FINAL SITE GRADING CONSTRUCTION PLANS
FOR
THE RIDGE AT LORSON RANCH FILING NO. 1
FINAL GRADING / EROSION CONTROL PLANS

EPC STORMWATER REVIEW COMMENTS
IN ORANGE BOXES WITH BLACK TEXT

COVER SHEET
FINAL GRADING AND
EROSION CONTROL PLAN

SF-22-004

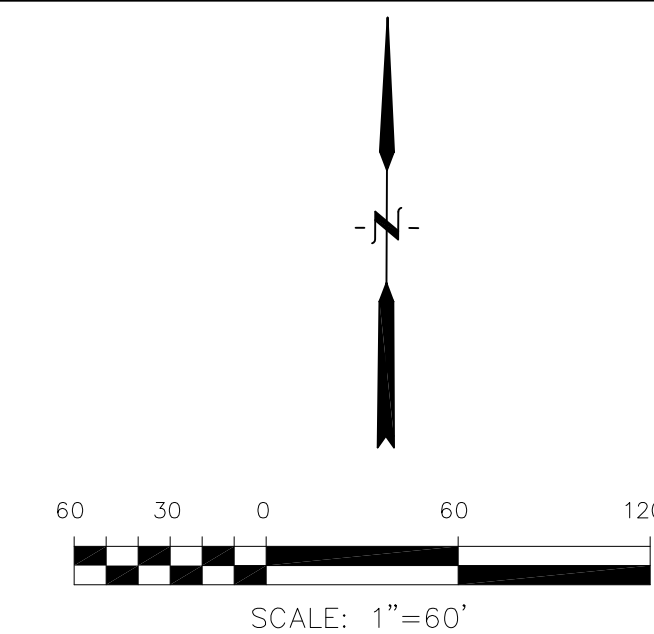
There is ~5ac of runoff tributary to this point, assuming a decent amount of flow will bypass the inlet because of the IP. So SF is not a sufficient BMP for this location. Use additional and/or alternative BMP(s) here.
